March 18, 1991
Project Number 60619

Curragh Resources Ltd.
Box 1000
Faro, Yukon
Y0B 1K0

RE: MARCH 5 SITE VISIT

Plate 1

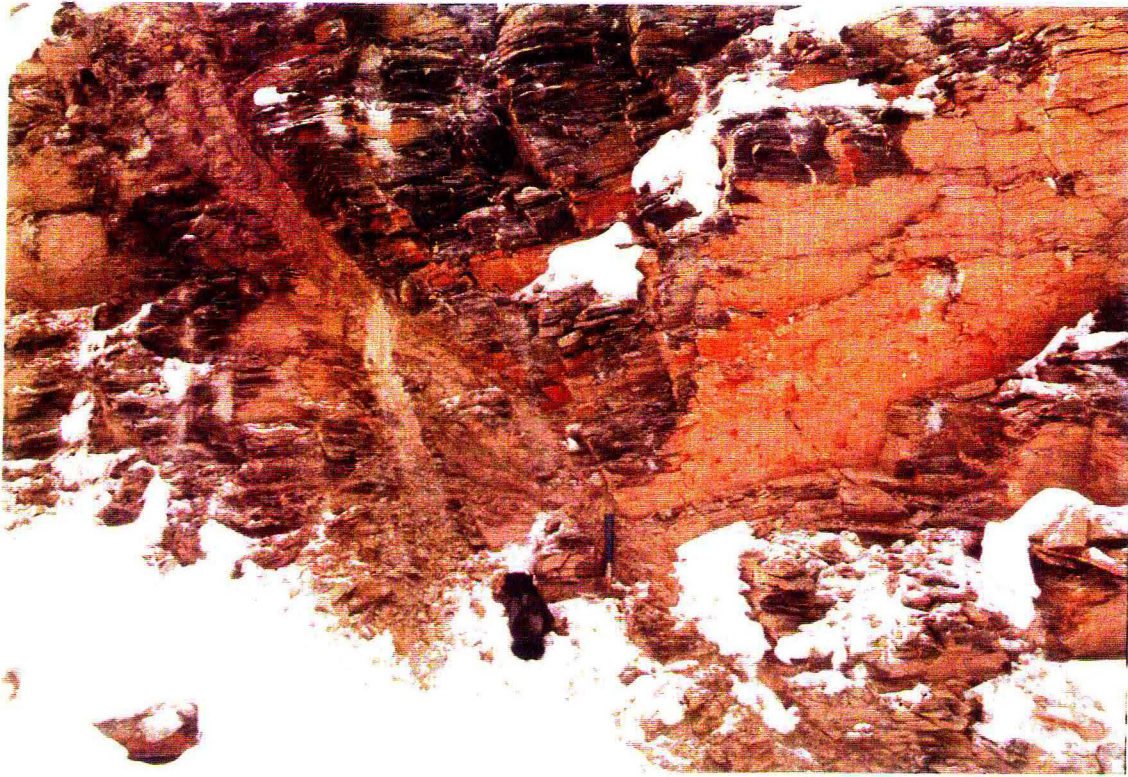
The proposed portal area was examined during the site visit. As was expected from core, the rock is very fissile but reinforceable (Plates 1-3). The RMR of the material is in the 20-30 range. The material is, however, extremely sensitive to vibration (de-lamination of the foliation planes). Only controlled blasting, with a minimum of explosives, should be used. Mechanical excavation, such as with a road-header machine, should be explored. Mechanical excavation would not disturb the rock mass, minimizing support. It may also be cheaper and give more rapid advance rates than standard drill-blast-muck excavation techniques. In either case, shotcrete or fibercrete must be used as support and to protect the rock from possible slaking.

Plate 3

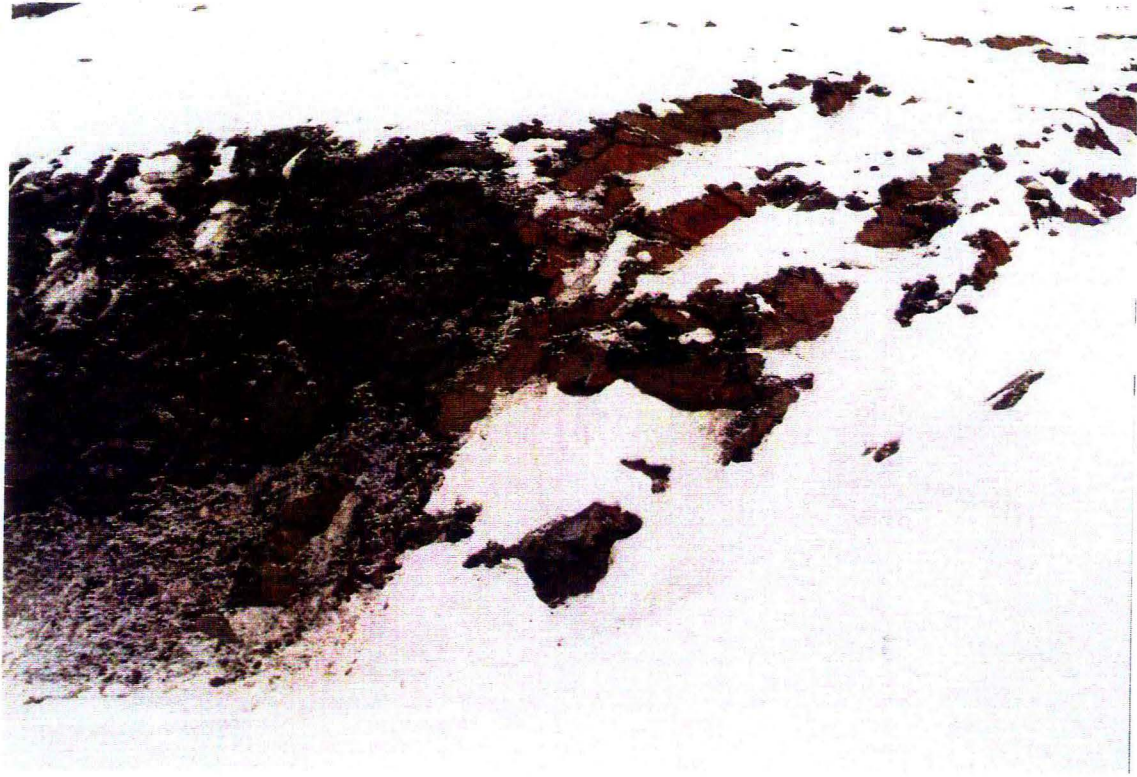
In addition, the soil composing the left side of the portal cut may become unstable during spring thaw. It appears as if the overall soil cut is too steep. However, this is an assessment made on a slope covered with snow and should be taken as such.

Plate 4

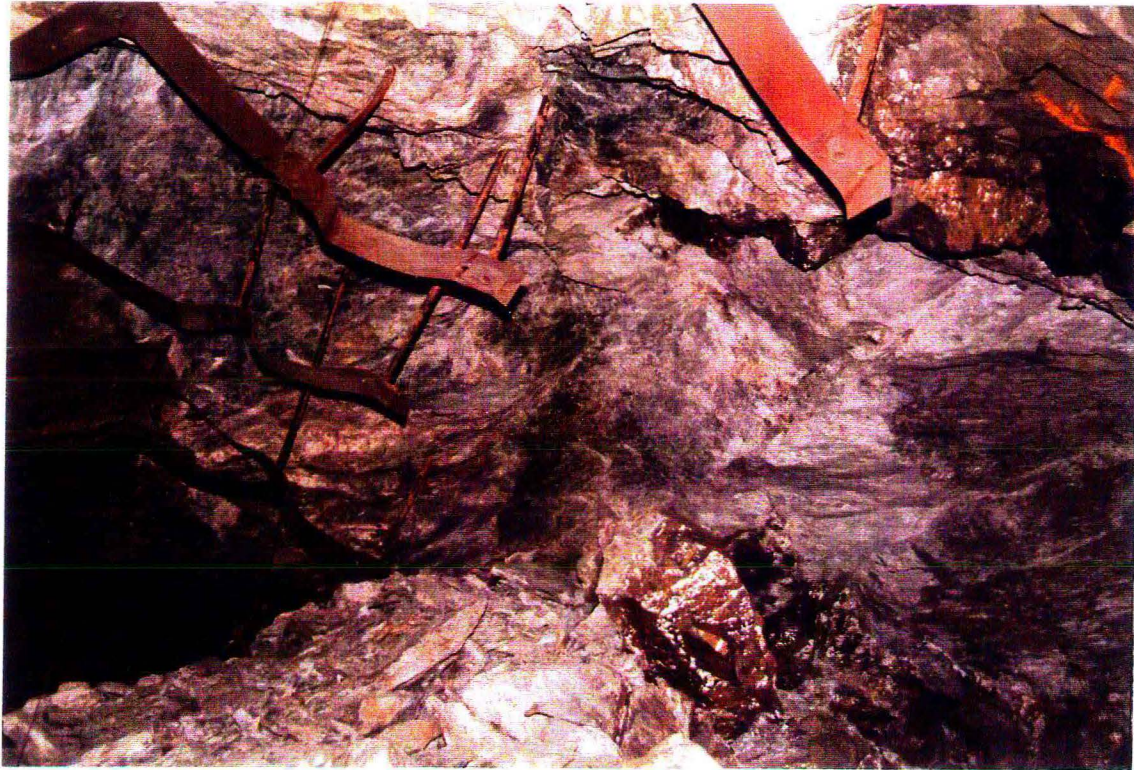
North extension where the drifts cross the dike defining the orebody limits, as well as in the South G ramp area. Frame 4 shows how the rock has peeled away from the split sets, leaving them not only unbent but still firmly anchored in the back. This is indicative of a rock substance failure. Shotcrete followed by bolting should be attempted in such areas.

Plate 5

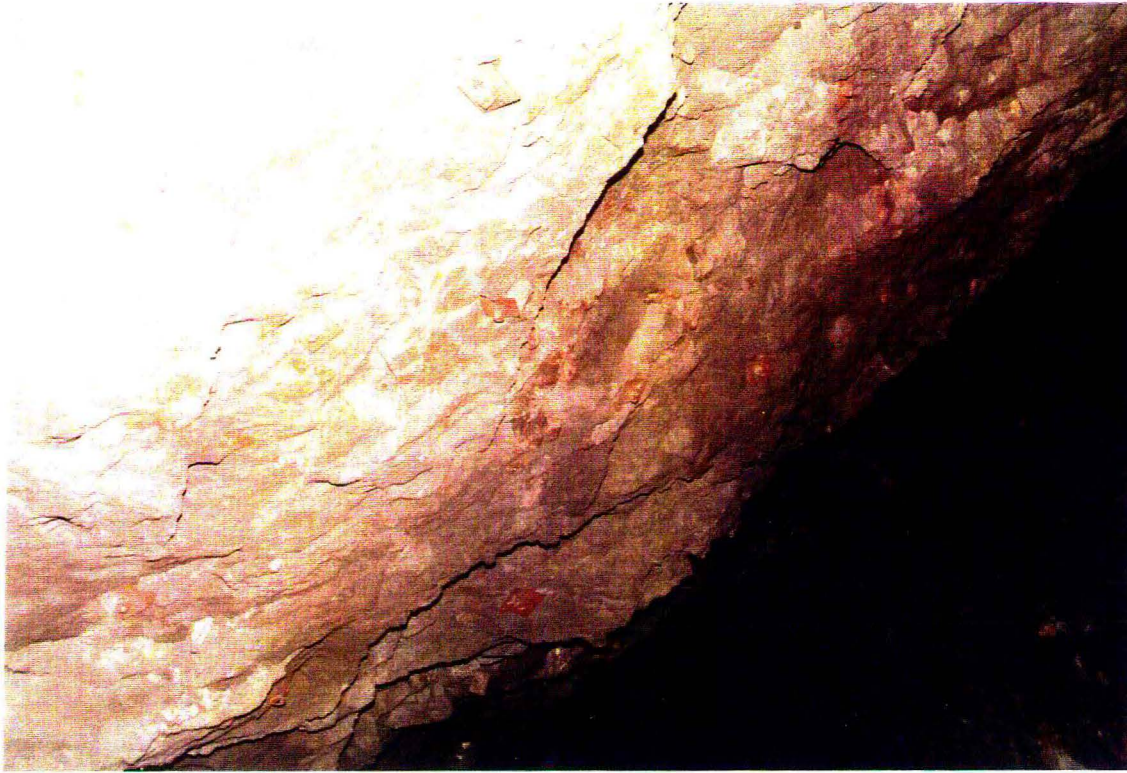
The one slusher stope which has been mined, although not technically a slusher stope, is not adequately supported. Mechanical rockbolts (Frame 5) are used almost exclusively in the back of the stope. Between 60-80% of these bolts are no longer tensioned (bearing plate not in contact with rock) and are therefore providing no support. The mining span is such that the back must be supported with a support system which does not need maintenance. This means that either split sets or grouted bolts must be used. Mechanical anchor bolts are dangerous if they cannot be maintained (re-tensioned) on a regular basis. They should never be used where they cannot be accessed.

Plate 6

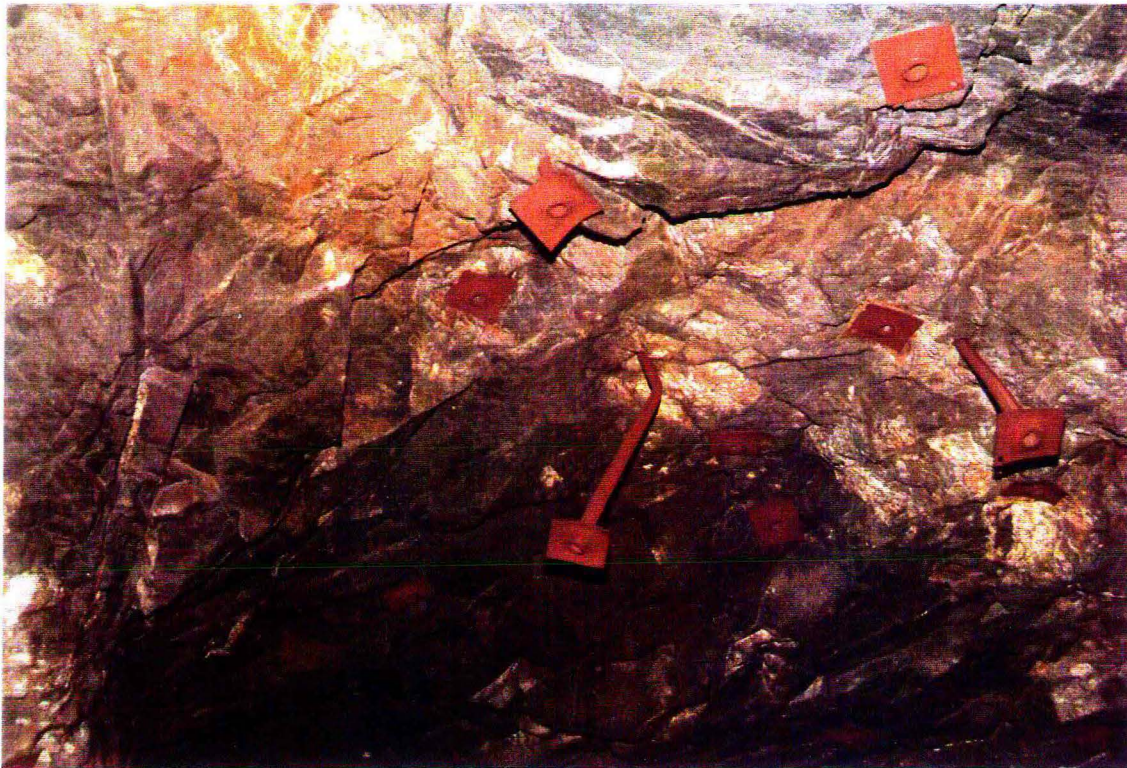
An examination of the South B stoping area uncovered very minor pillar spalling, indicating that the pillars are beginning to take some load. Bearing plate bending (Plate 6), between some of the pillars in the area, may indicate that the back is beginning to sag slightly. The conditions of both pillars and spans between pillars should be monitored on a continuing basis.
